**N6705A-05B-S**

# **S E R V I C E N O T E**

## N6705A DC Power Analyzer

### POSSIBLE SHOCK HAZARD

**Figure 2.** Demonstration of properly installed safety ground connector

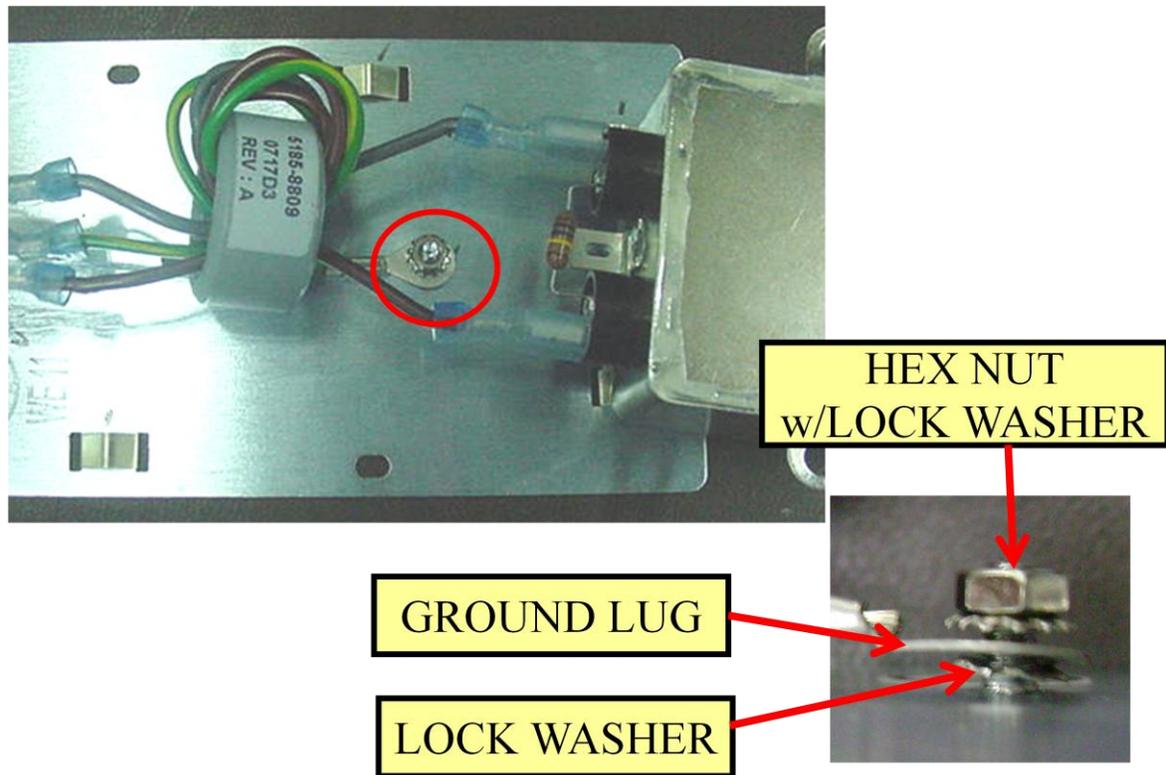
The hex nut, which secures the safety ground to the AC Input Filter Module (P/N 9135-5209) needs to be verified to have been installed with 9 inch-lbs.

1. Secure Green/Yellow wire of the AC Input Cable to the Shroud Top using a M3 Hex Nut w/ Lock Washer (P/N 0535-0031).

**Note : Ensure hardware is installed in the following sequence. Lock Washer – Ground Lug – Hex Nut**

2. Torque to 9 inch-lbs.
